FINAL ENVIRONMENTAL IMPACT REPORT

VOLUME 1 COMMENTS, RESPONSES, AND ERRATA

**DOUGHERTY VALLEY GENERAL PLAN AMENDMENT,
SPECIFIC PLAN, AND RELATED PROJECTS**

November 1992

Figure 5-6.
Unimproved Open Space
in the Dougherty Valley
Planning Area

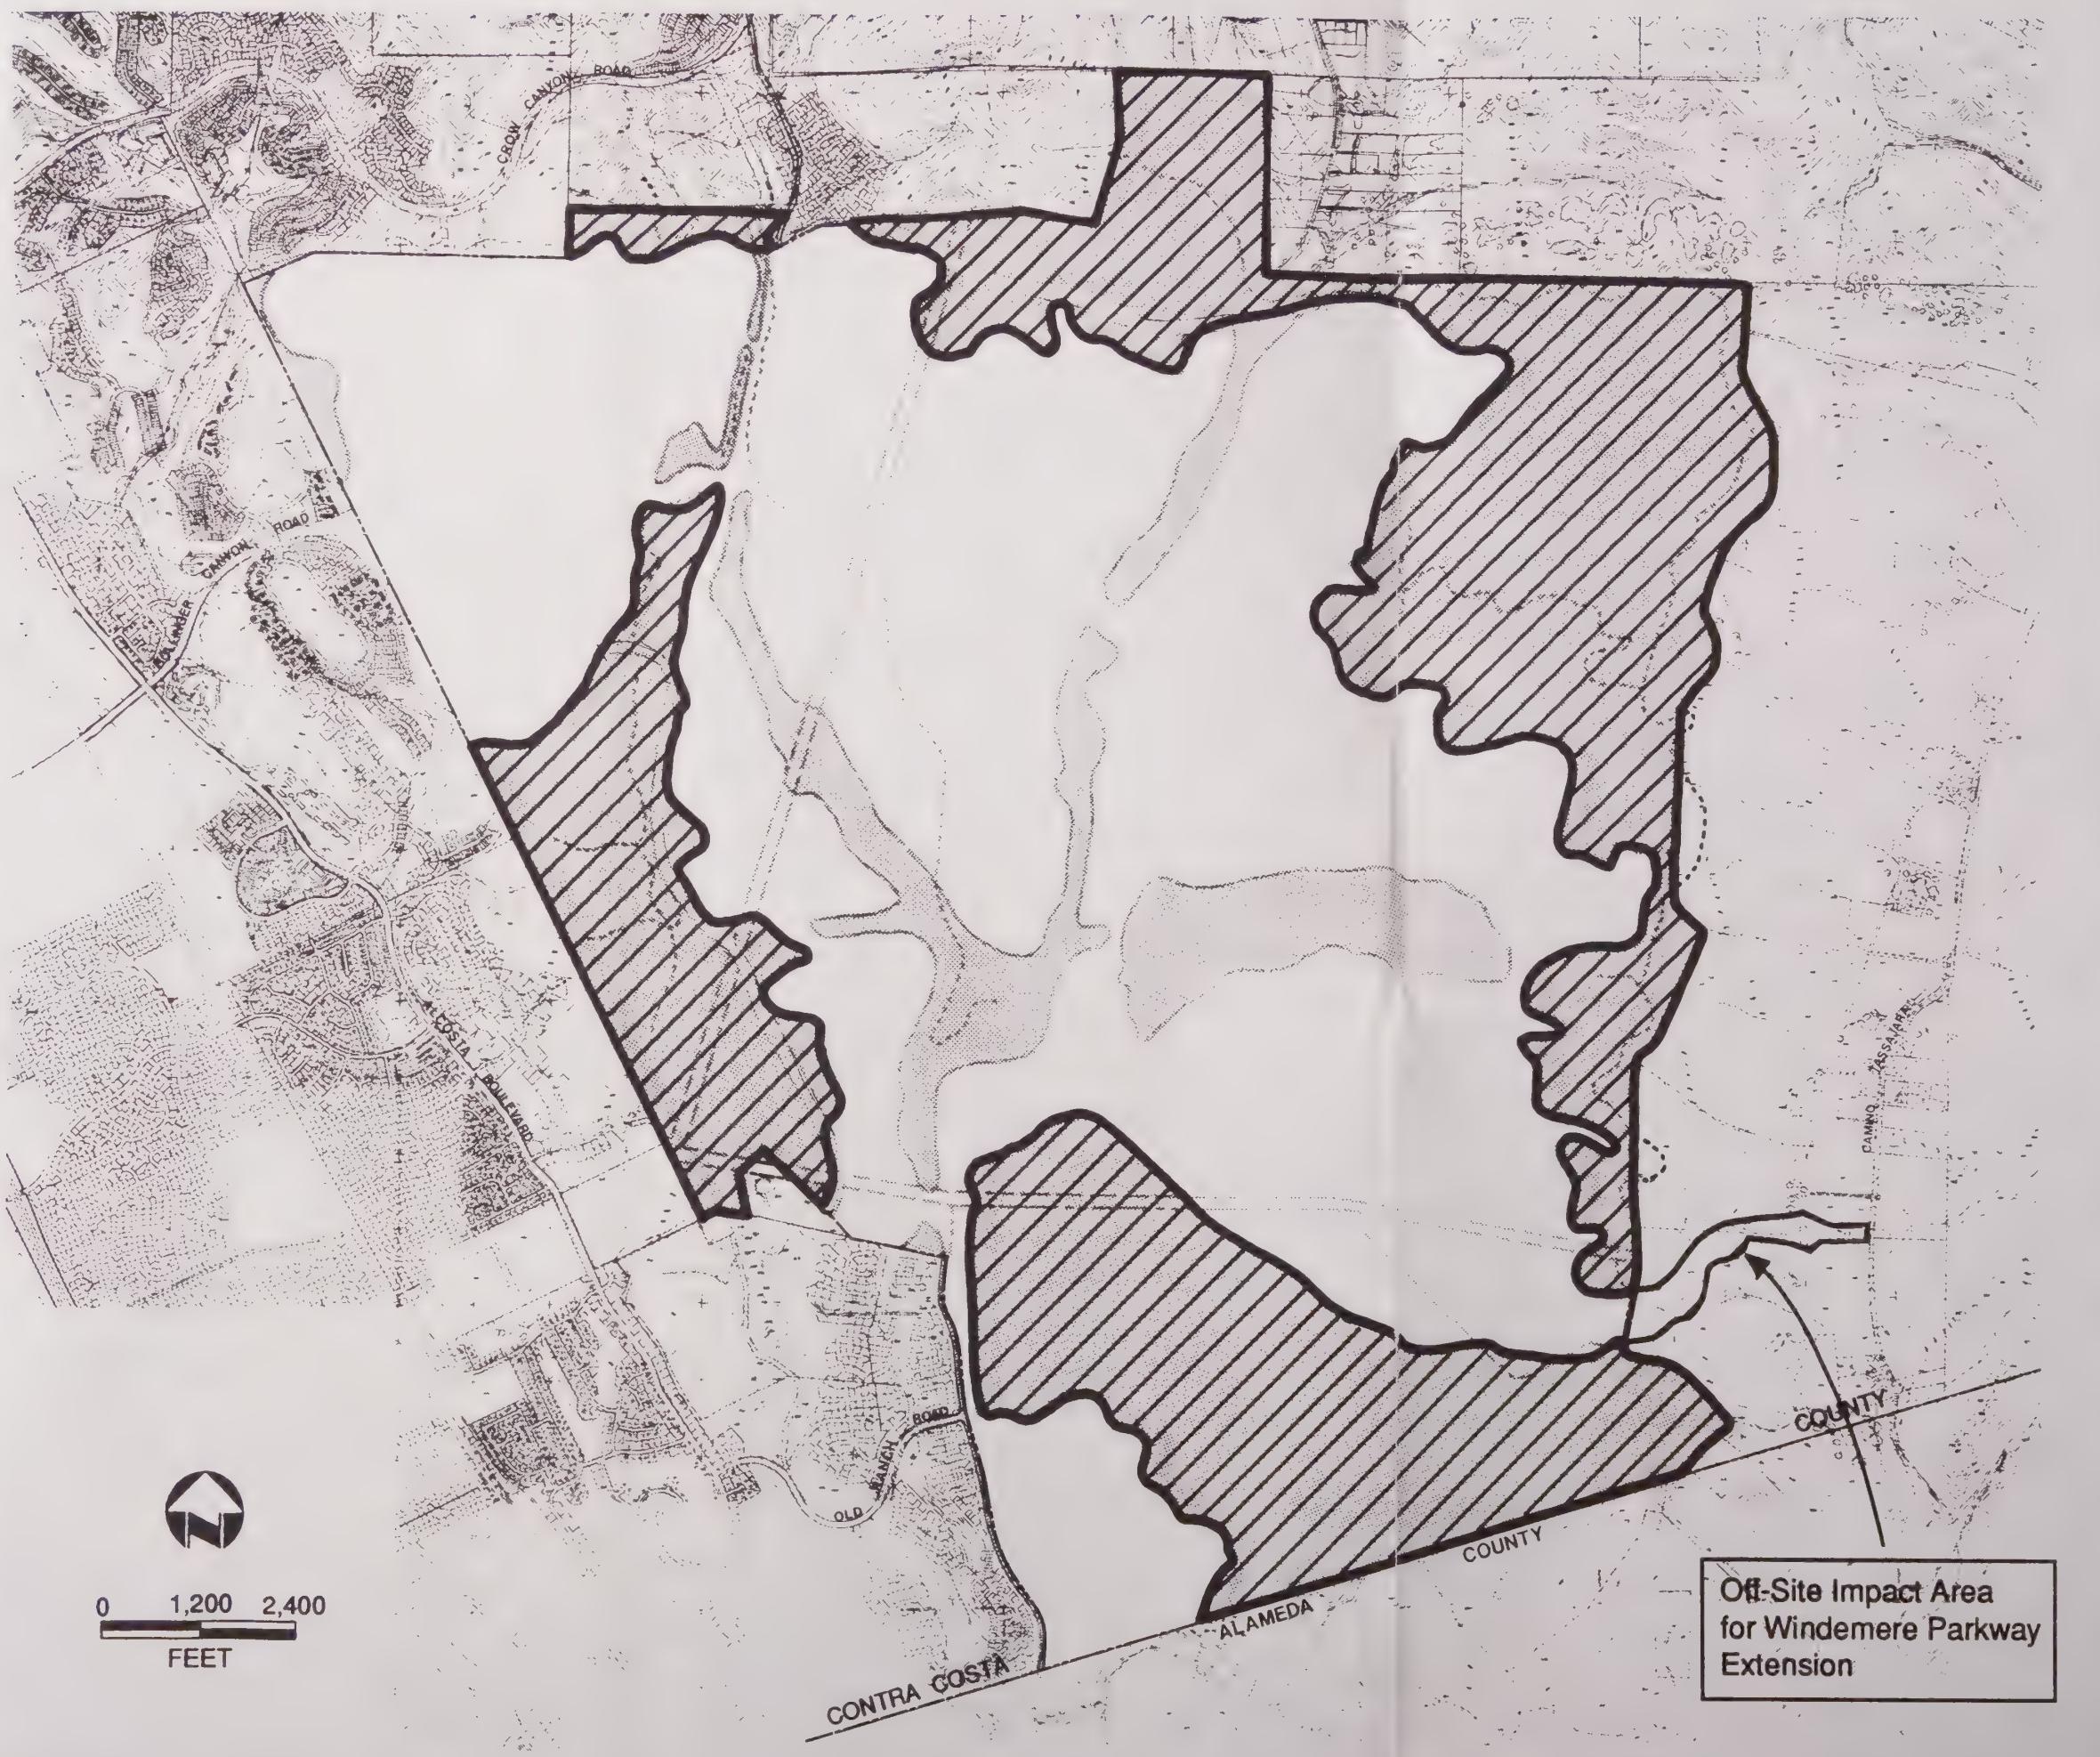
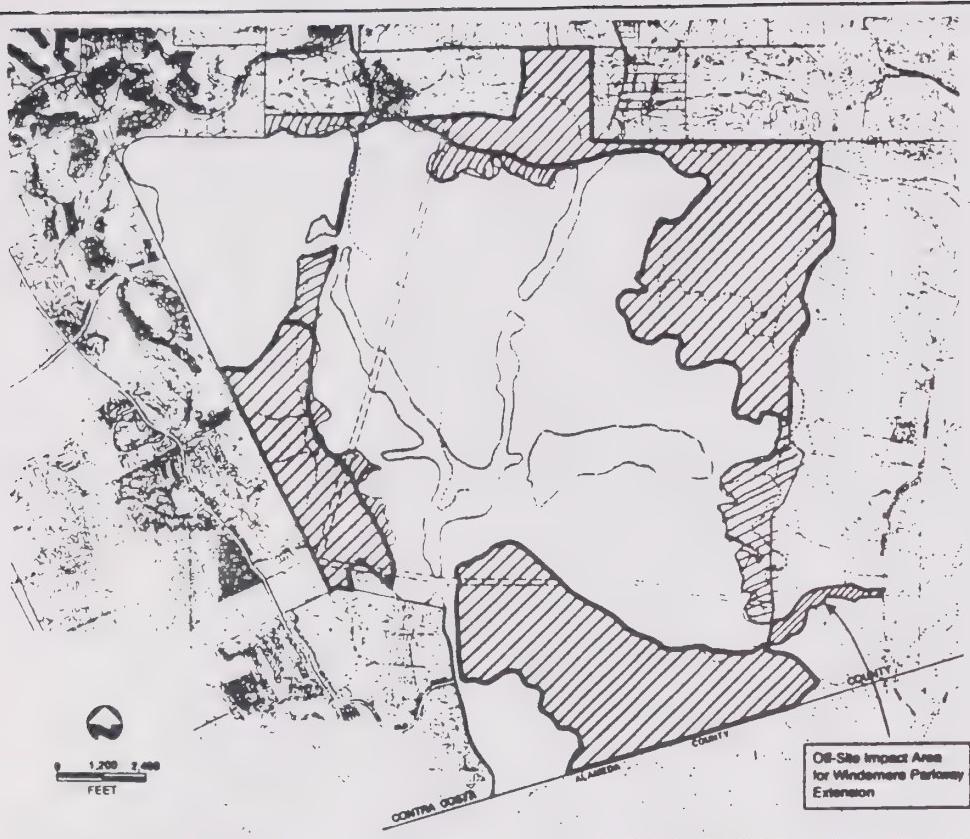
Last but not least, on Figure 5-6, the last name of the undersigned is misspelled.

Add newly crossed
areas

Figure 9-11. Alquist - Priolo Special Study Zones

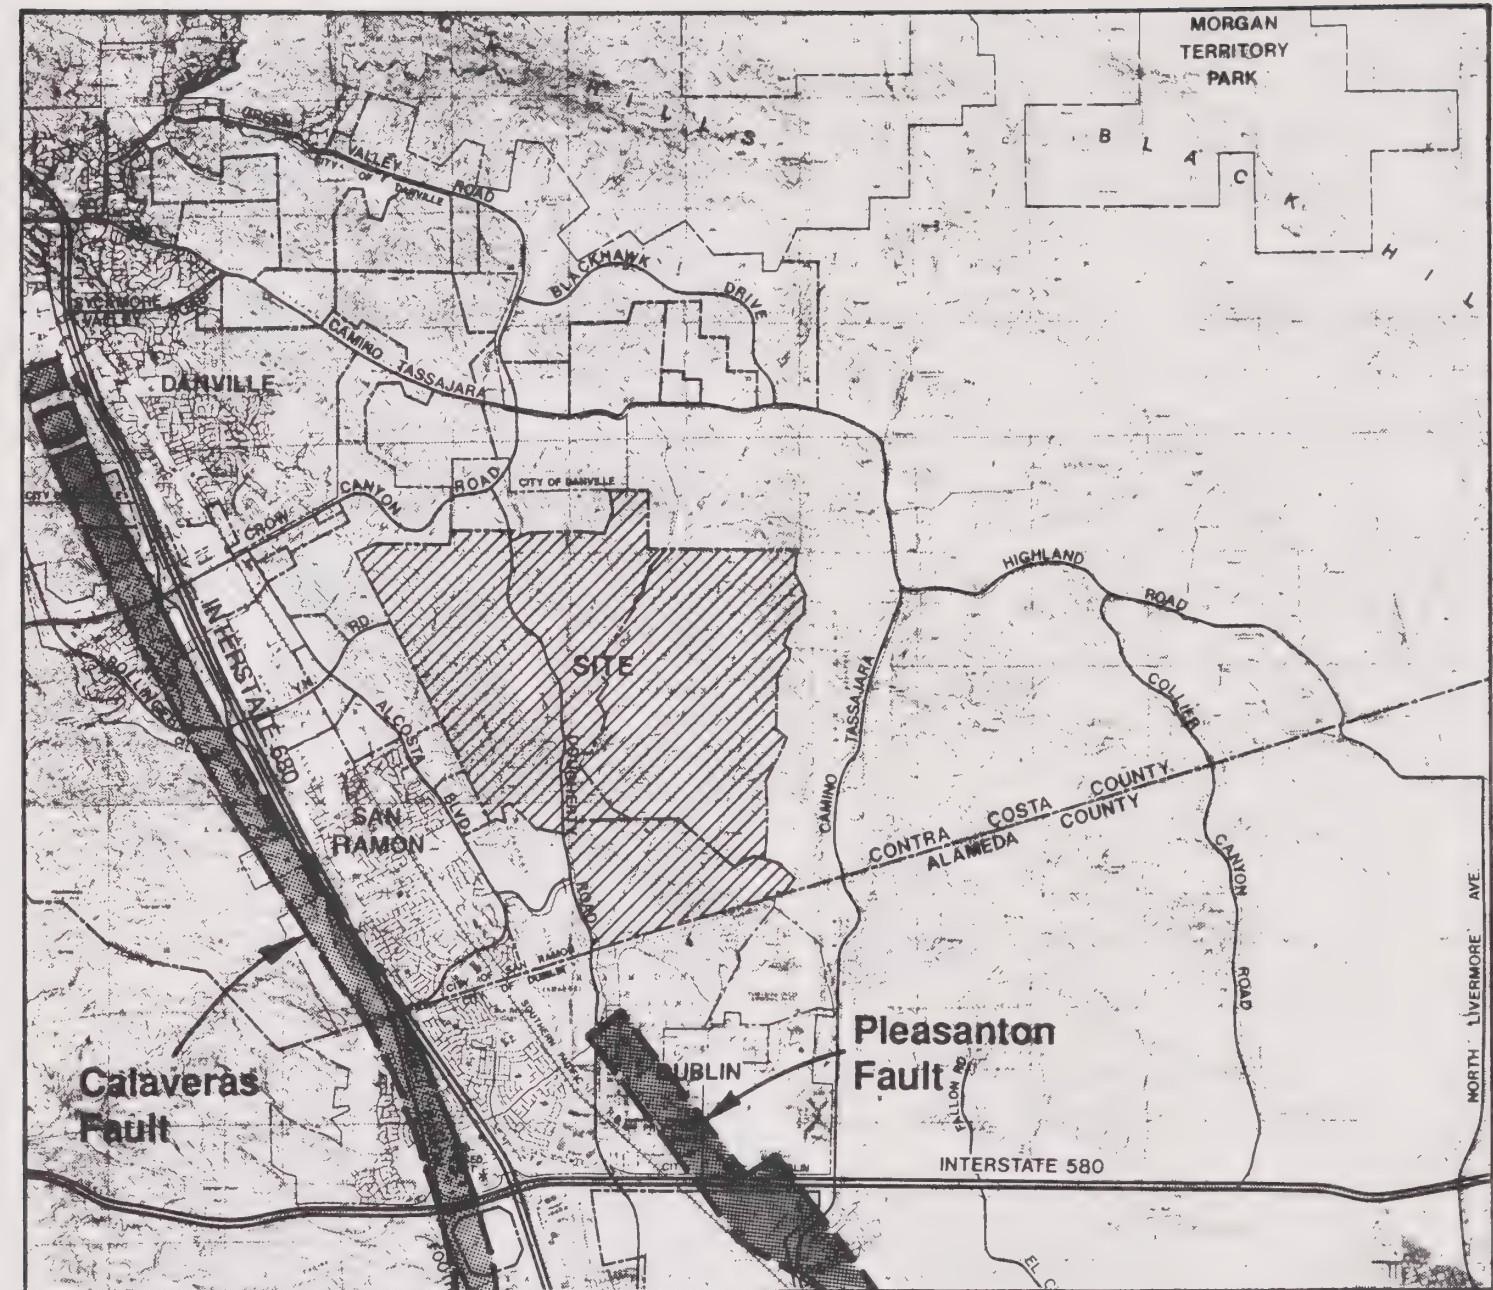
Page 9-13 - Figure 9-11. The Calaveras Fault is Incorrectly located on the East side of the freeway. Examination of San Ramon's General Plan would provide the correct location.

- 5-58 This comment identifies an error in Figure 9-11. The figure is amended to correct this. Refer to the Errata in the Final EIR.
- 5-59 Cut-and-fill maps are provided in the Draft EIR (pages 9-6 and 9-7). Mitigation Measure 9.1 requires that the project proponents prepare a detailed grading plan prior to the approval of the final development plans. If the grading plan indicates that there may be significant adverse impacts that were not addressed in the EIR, further environmental review will be necessary. CEQA does not require that all permit applications needed to construct a project be submitted prior to certification of a project EIR. Refer to response to Comments 5-1 and 5-2.

5-58 Refer to revised Figure 9-11.

Figure 10-4.
Potential Dougherty Valley
Detention Basin Locations

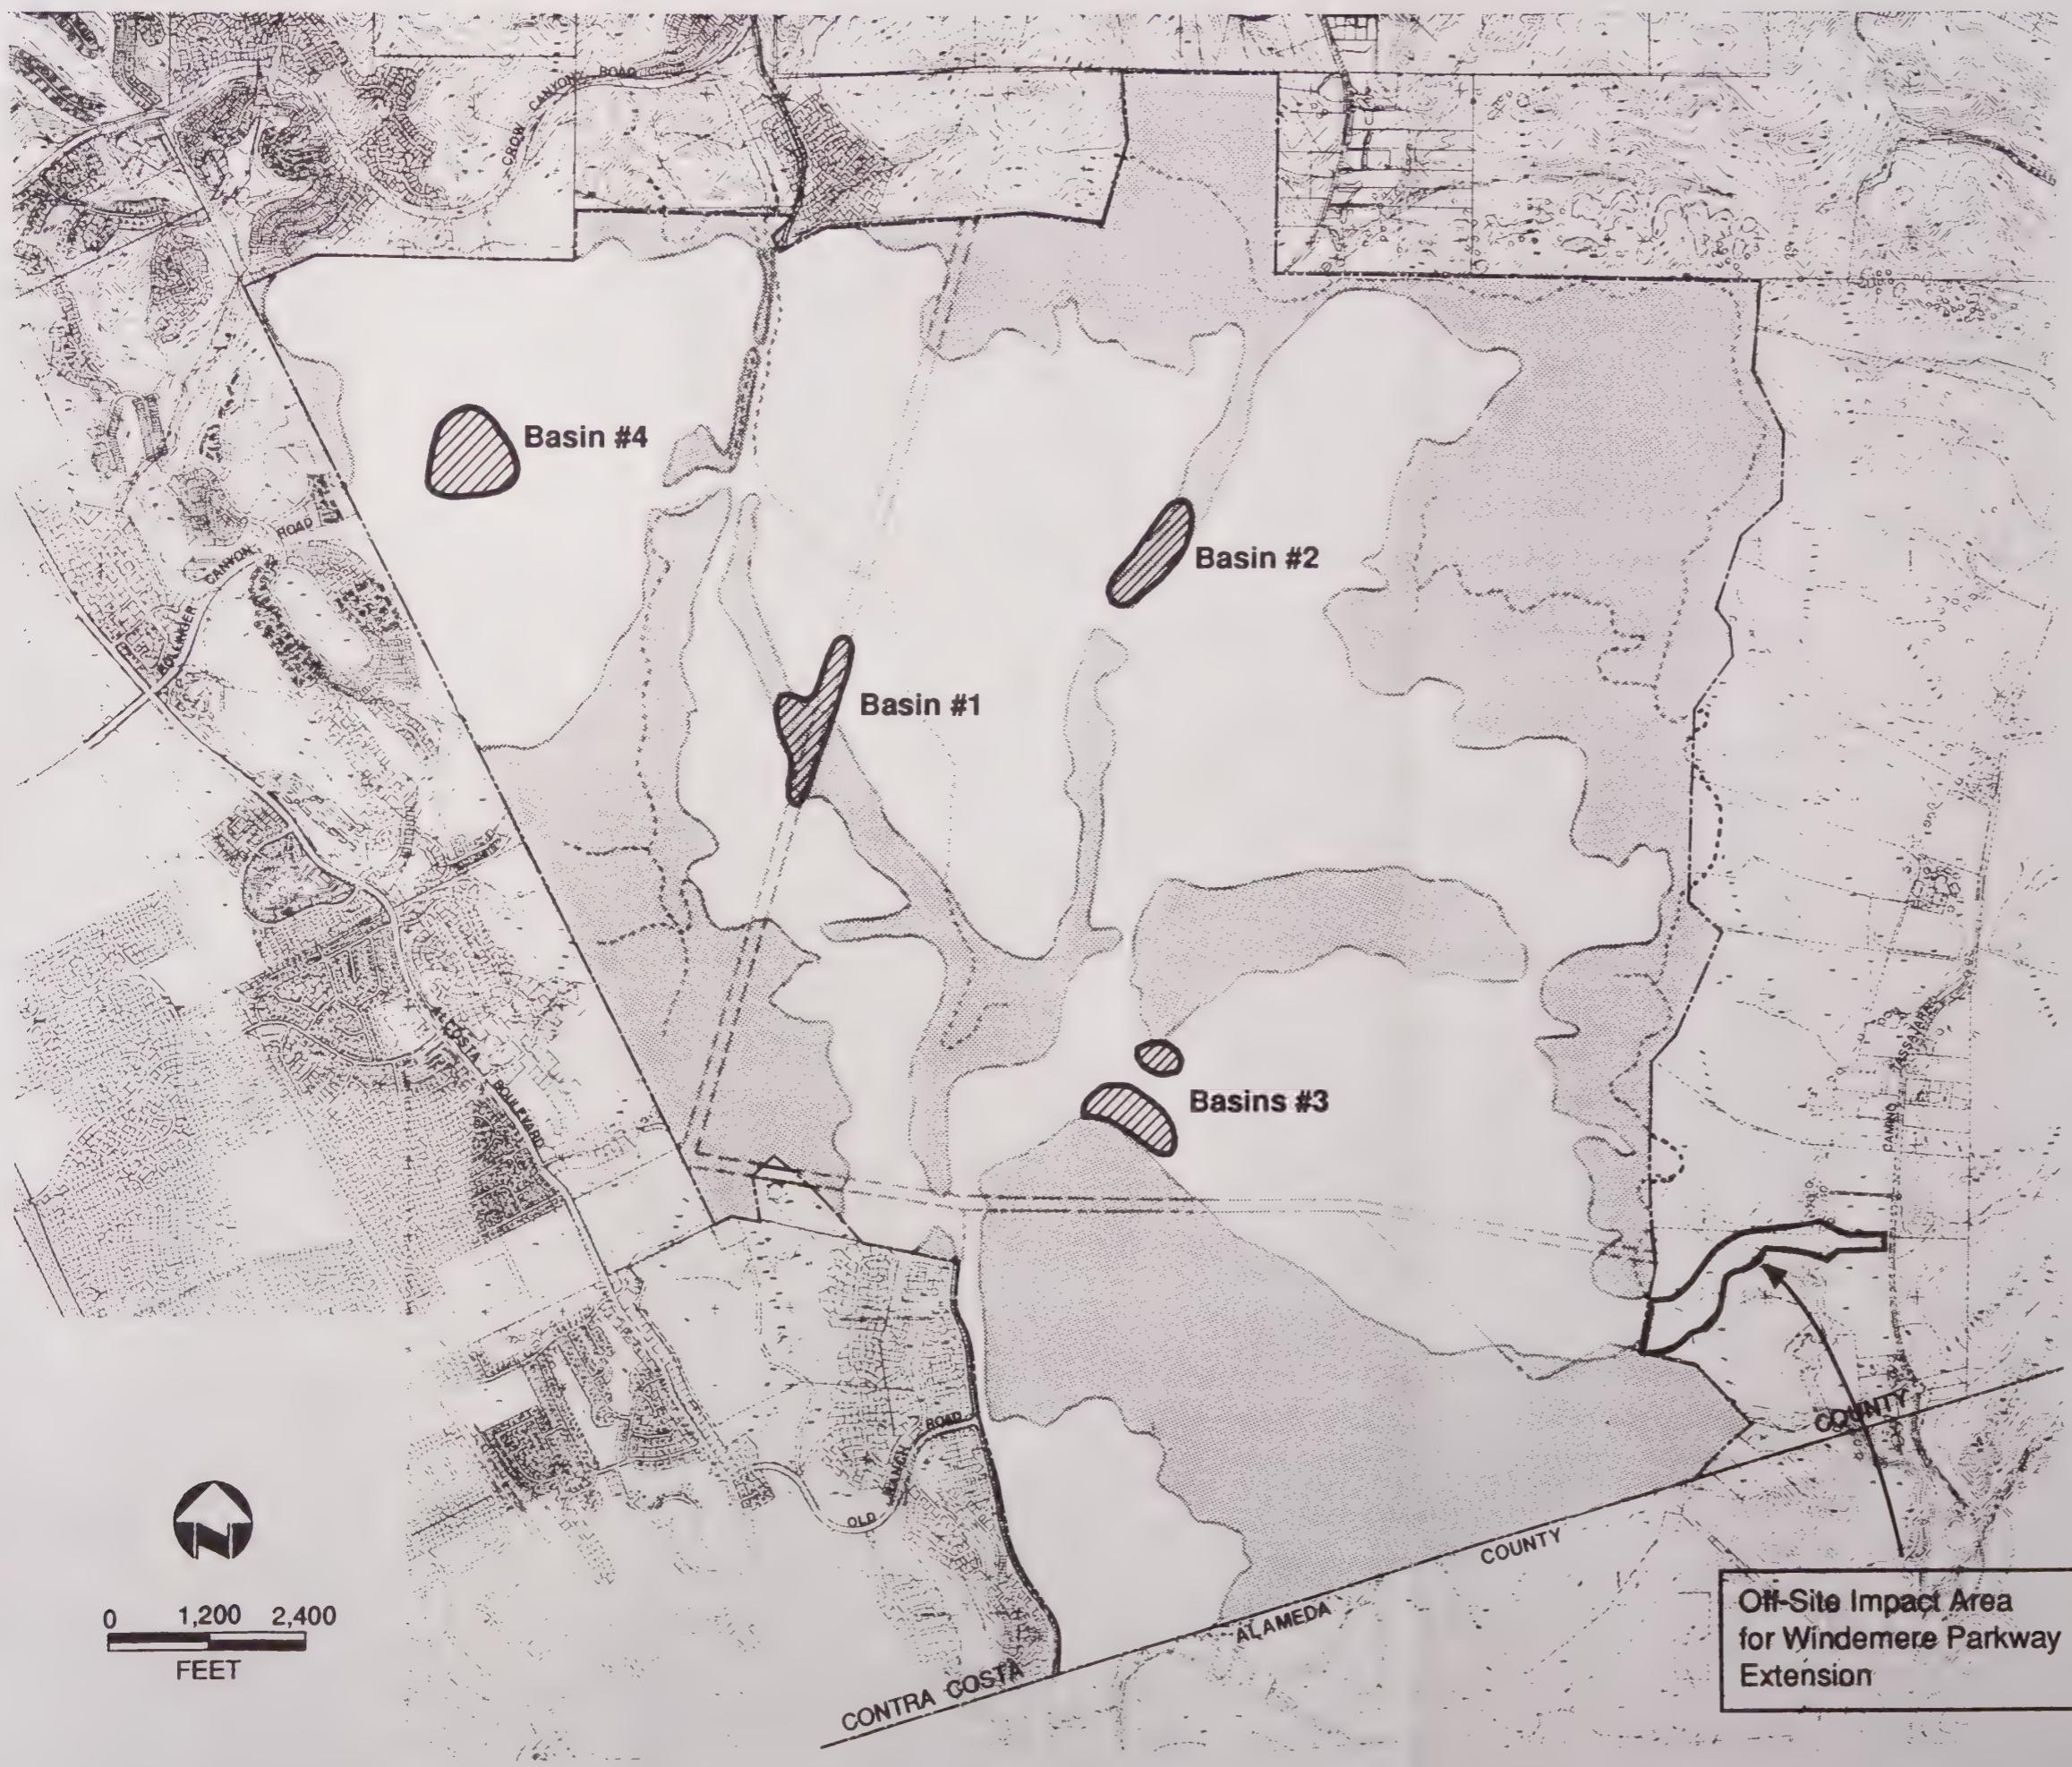
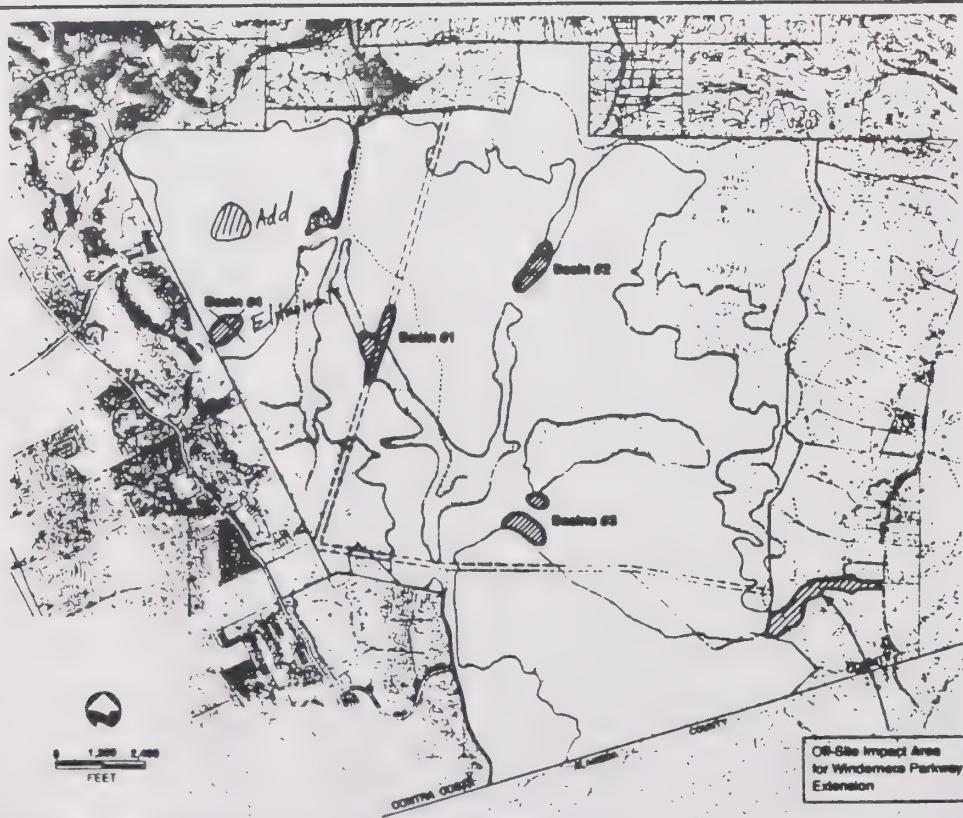
Figure 10-4 - The location of Basin No. 3 is at the intersection of Windemere Parkway and Bollinger Canyon Road, as well as encompassing some of the single family residential areas. All other detention basin locations are located within parks or open space designated areas. The EIR needs to incorporate mitigation measures to ensure that the construction of this detention basin and long-term use will not negatively impact surrounding land uses.
